**Re: Botley West Solar Farm — Development Consent Order Application
(PINS Ref EN010147)**

**Stop Botley West Campaign Response to the Applicant's Answers (submitted 9 June 2026)
to the Secretary of State's Request for Information dated 14 April 2026 (as revised 20 and 28
April 2026)**

Response to Applicant's Answers [C1-087]
to the
Secretary of State's Request for Information

Residential properties survey
Figure: 2.17

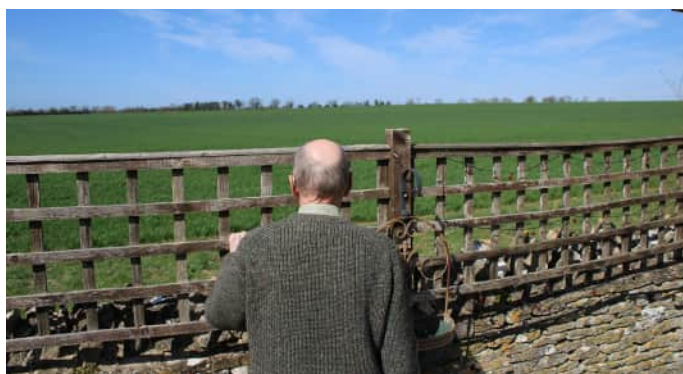
Applicant's dark photo taken towards the house claims "*vegetation filters views*". SBW's photos look outwards from the garden of the house across an open fence onto fields proposed for panels with 40m.

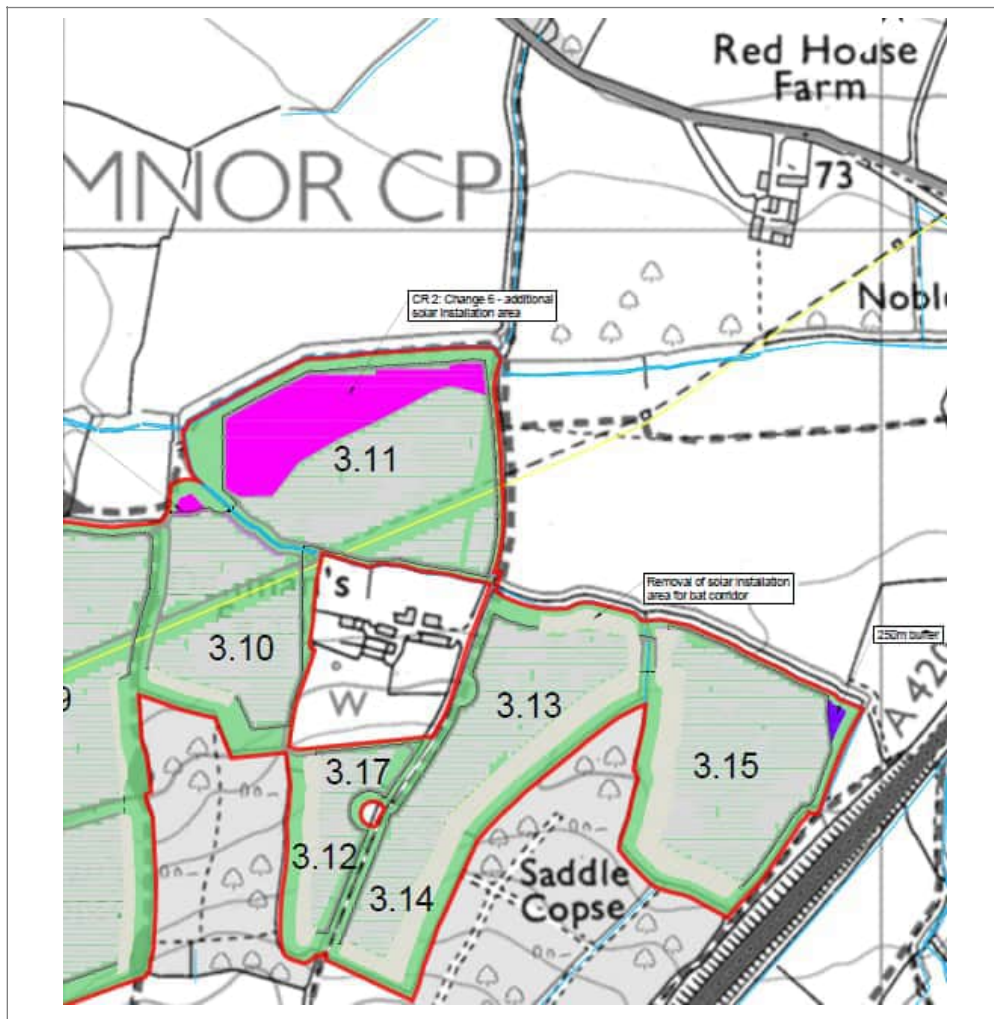
- Given that the redlines for the Red House Farm power station and Botley West’s southern site are co-located for much of their East – West alignment in Cumnor Parish, the SoS should assume that bats present in the Red House Farm survey will also be present within the Botley West southern site redline.

Unless this Applicant is claiming that bats in Cumnor Parish do not cross planning application redlines, it would be perverse to insist that bat species recorded within the Red House Farm redline, given those recordings include bats crossing the redline to the south into the area within the Botley West redline, somehow are not present within the Botley West redline, and vice versa.

- That being so, the Applicant’s oLEMP describing the southern site is deficient, needs to be withdrawn and resubmitted after it has conducted a more comprehensive – and so representative - bat survey.

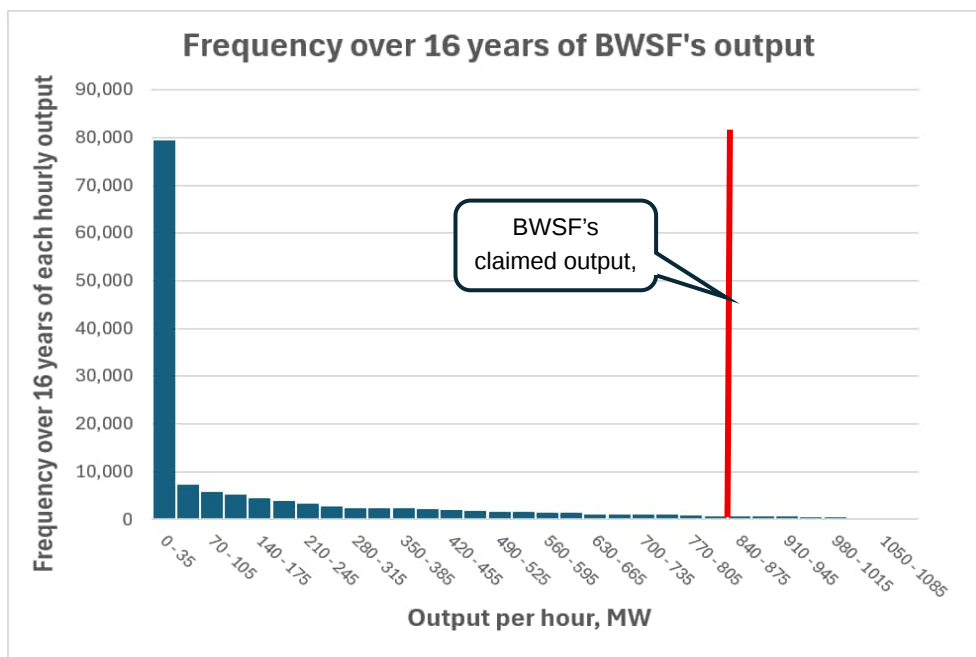
The average results show that in a 1307MW capacity system, an 840MW output is exceeded just over 2% of the time (as reported in the legend of Fig. 1). BWSF's

performance is particularly poor in Winter when its output reaches more than 500MW less than 2% of the time. Even the comparable Summer figure (c. 17%) is quite poor.

Figure 5. PVDP's figures relating BWSF's Capex (£Millions, y-axis) for various installed capacities (MW, x-axis). Note the linearity of the data and the apparently large, fixed costs (implied by the intercept of the line with the y-axis)

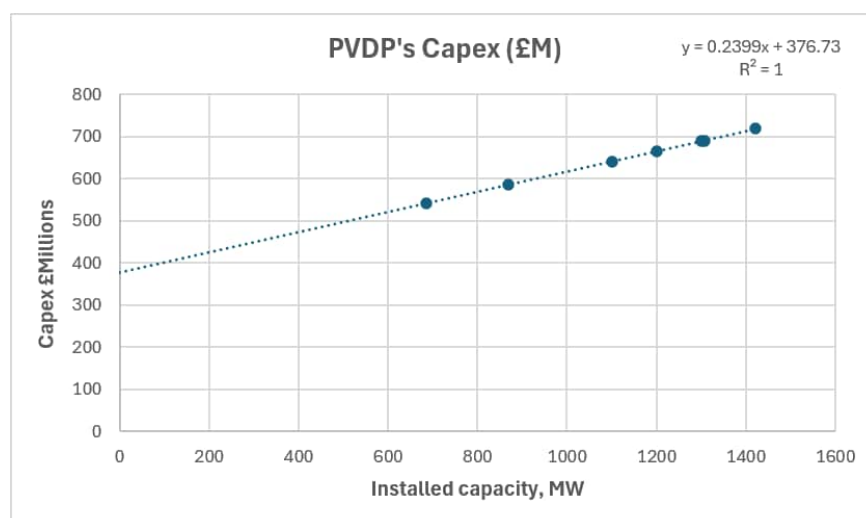
The applicant's figures for total Capex and for Capex/MW installed capacity (in para. 68, **C1-087**) are shown graphically here in Figures 5 and 6.

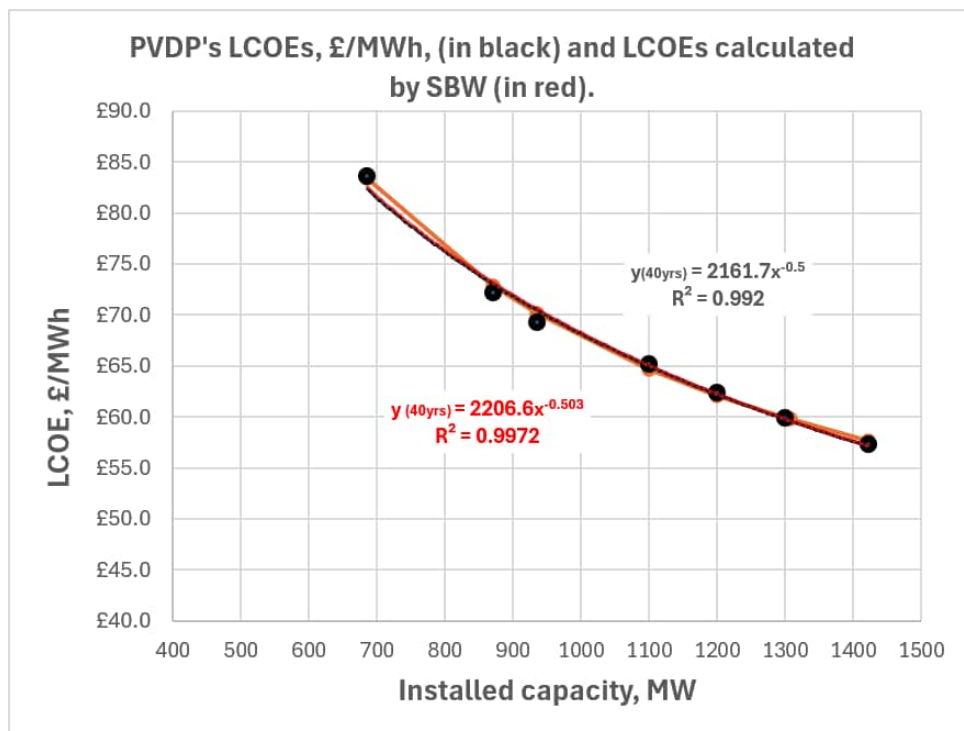
Once again, our figures are sufficiently similar to those of the applicant that we can examine (and question) what assumptions the applicant may have made in producing them.
